Planning Application Information Sheet

Application Type: Development Variance Permit

File Number: 3090-20/20210012

Location: 1653 Beach Crescent

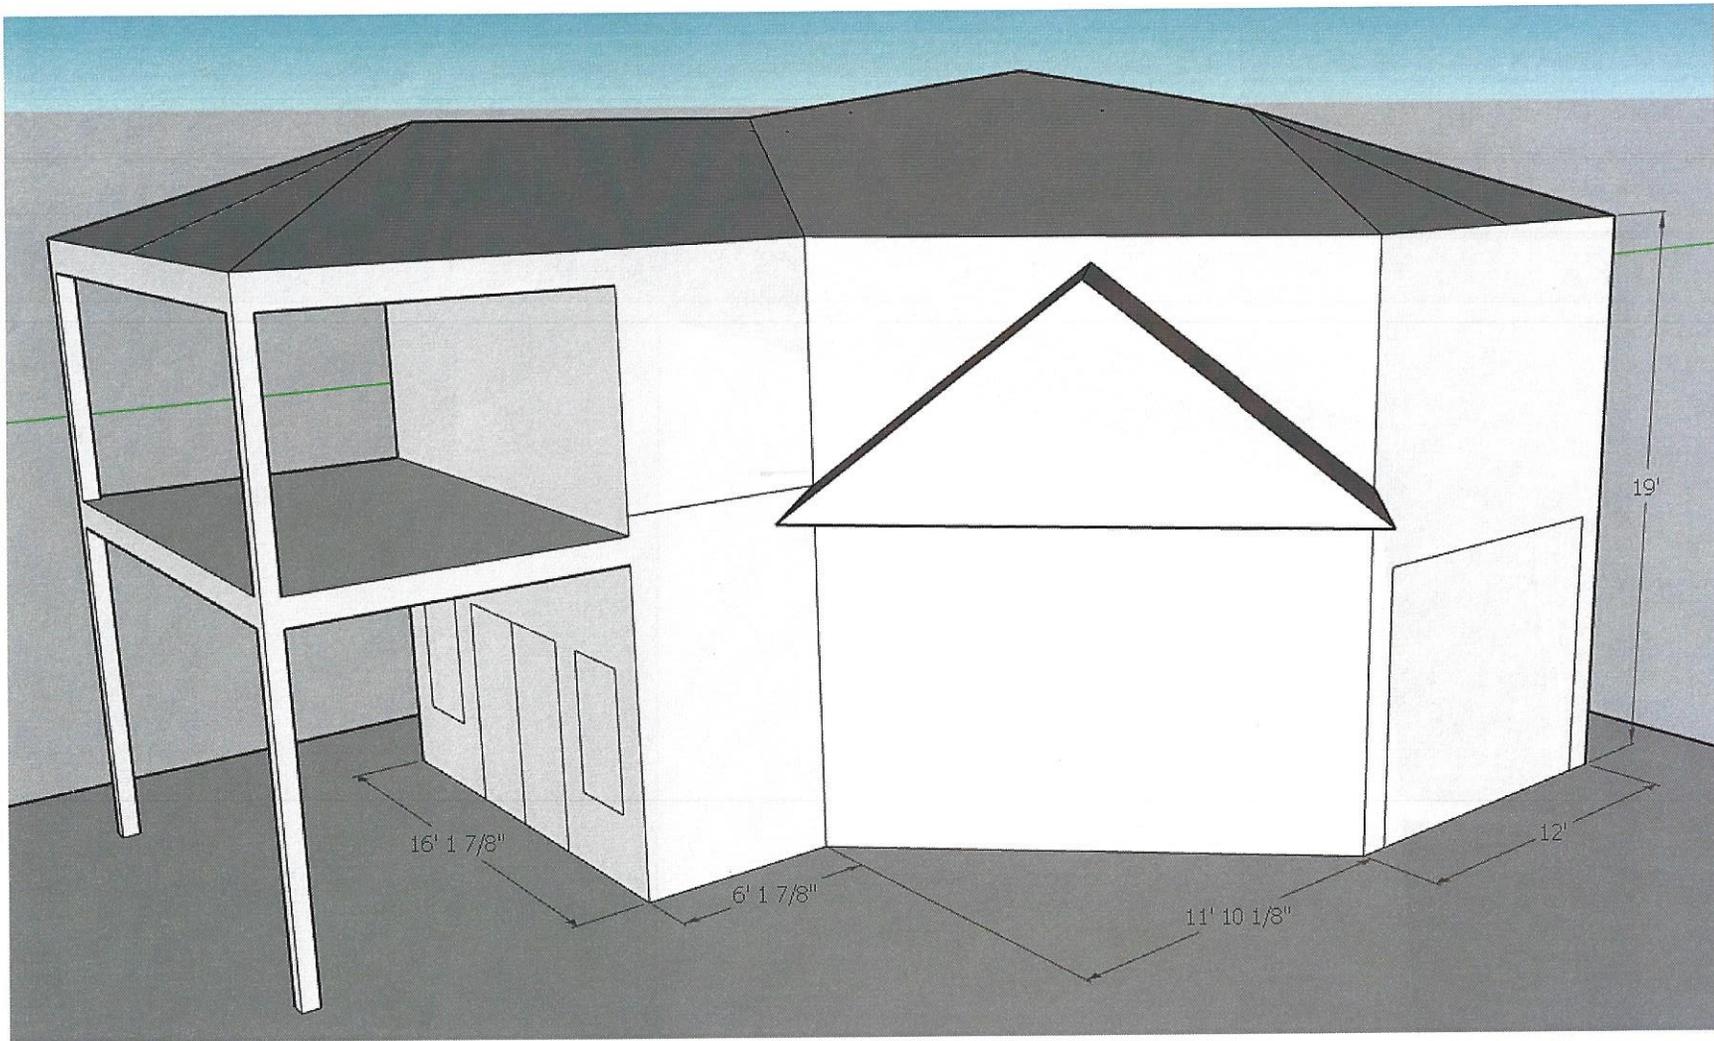
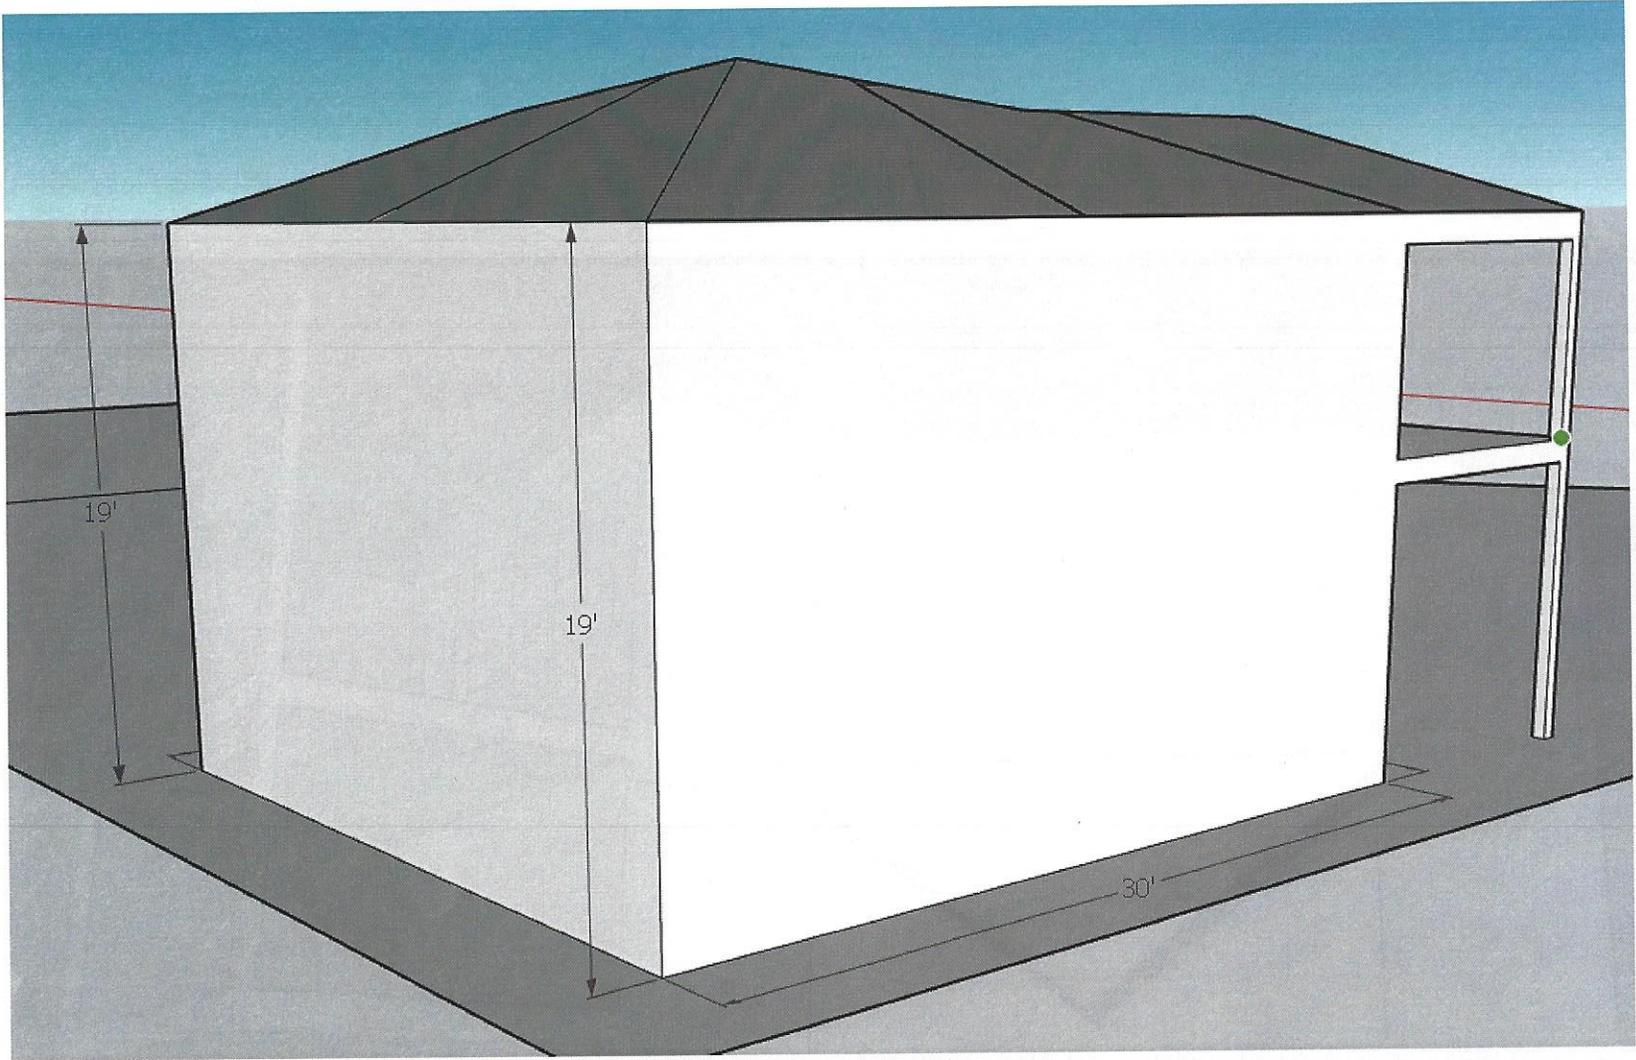
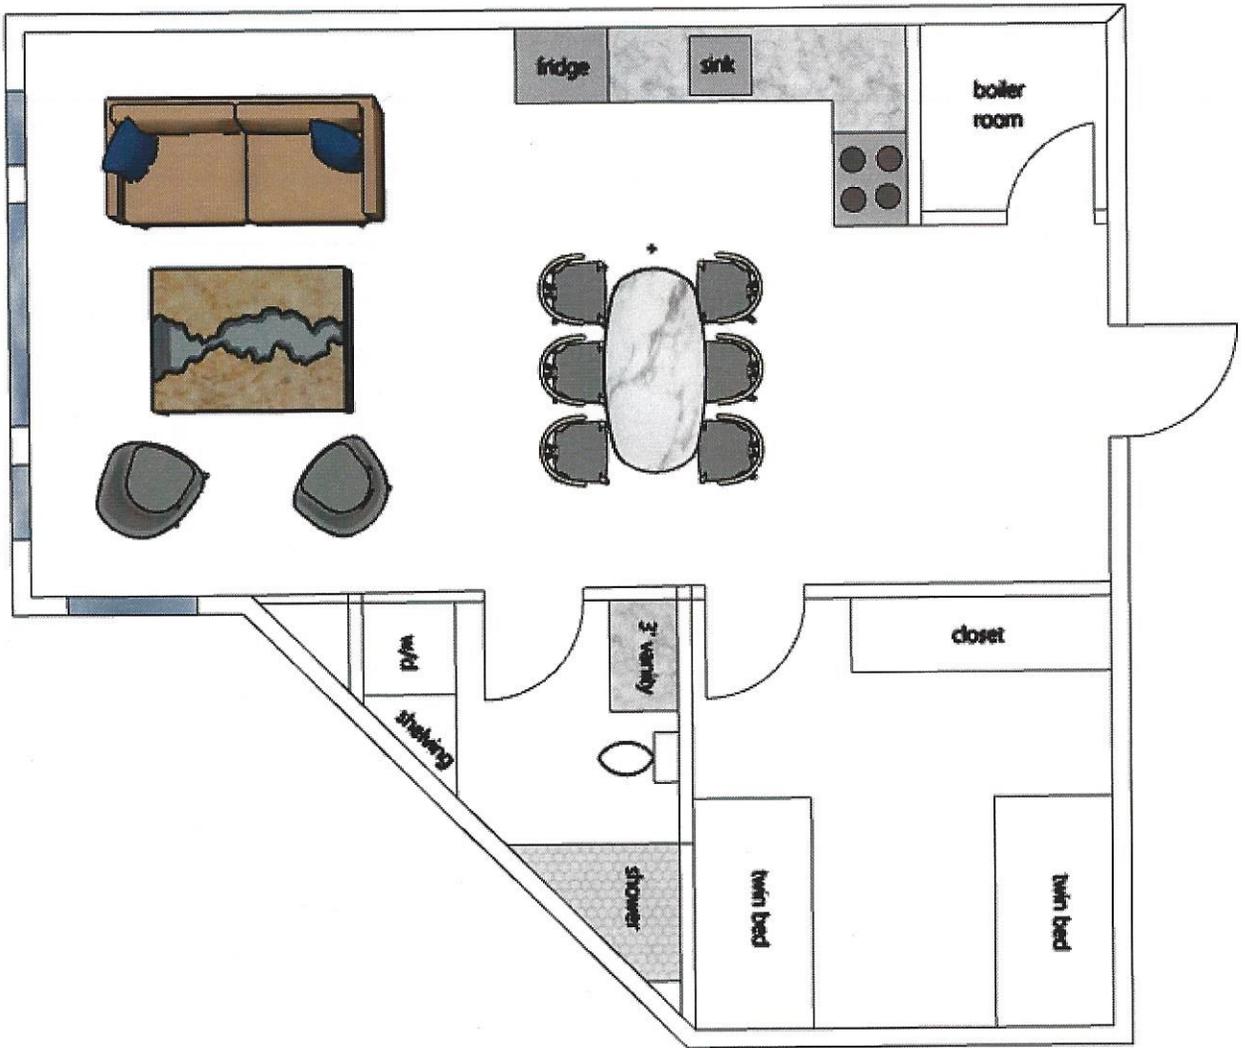
Also, I have other objections based on the floor plan that was included. It appears there is a plan for a door that would be facing Lot 2. Does the variance to 1.5 m include the swing of the door and its landing or just the placement of the wall? A normal door is about 1 metre wide. This would leave less than 0.5 m between the open door and my fence.

It would be reasonable to assume that the reason for a setback of 3 m (in the first place) would be to allow for things such as (but not limited to) doors, awnings, stairs, roof overhang, fire exits, and eaves. This exterior door on the floor plan appears to be leading directly into the suite, which is on the second floor. This means there must be a staircase on the outside of the building to get to that door. A staircase and its landing have to be wider than the door swing, so this puts the staircase even closer to my property than a simple door would. If the wall is built 1.5 m away from my property, AND a staircase is added between that wall and my property, then it is far too close.

I need clarification in writing as to where the wall is to be built and how close any part of this building will be to my property line before I can remove my objections.

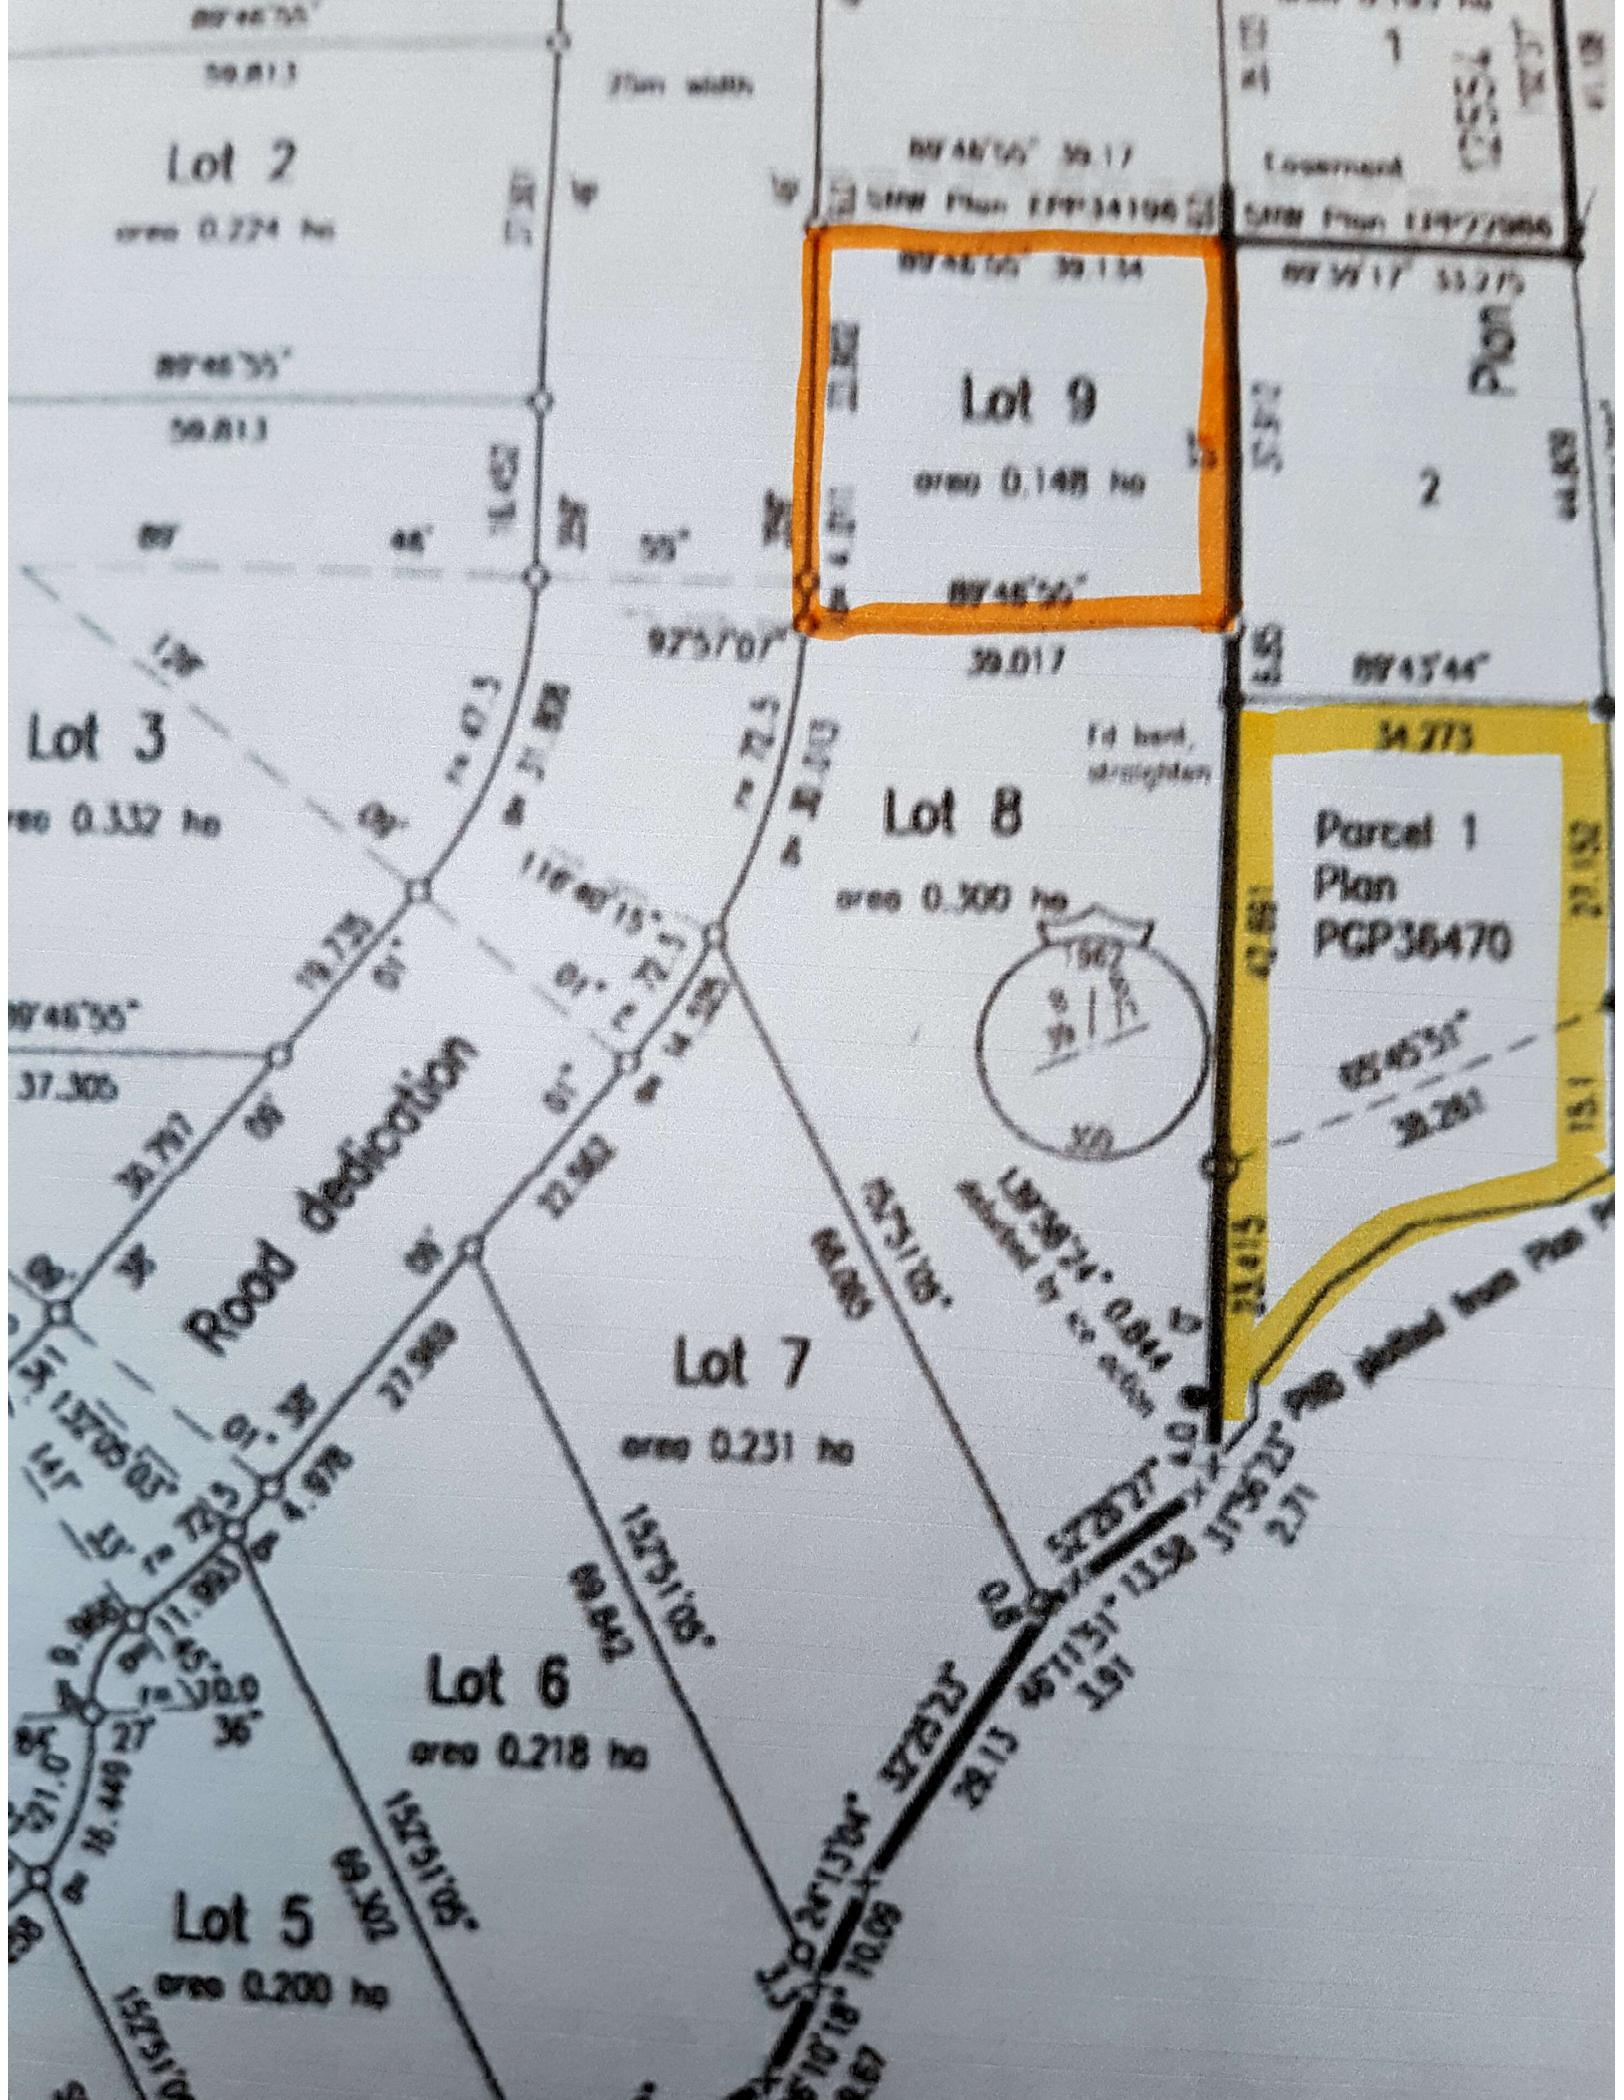
The adjacent property to the immediate north of the subject property is currently vacant and apparently in probate. Therefore the question is who is able to represent this property and if sold in the near future?

We are located on a view lot north west of the subject property. Lot #9 DL3971 Cariboo District Plan EPP33897 (outlined in orange on attached map).

Based on the proposed building construction, it appears the proposed garage with a carriage house would have a similar height to the existing residence. This would definitely obstruct a portion of our view. We purchased this property based on it being a view lot, and the City of Quesnel is taxing it as such. We purchased this lot and are planning our dwelling to take advantage of the lake view.
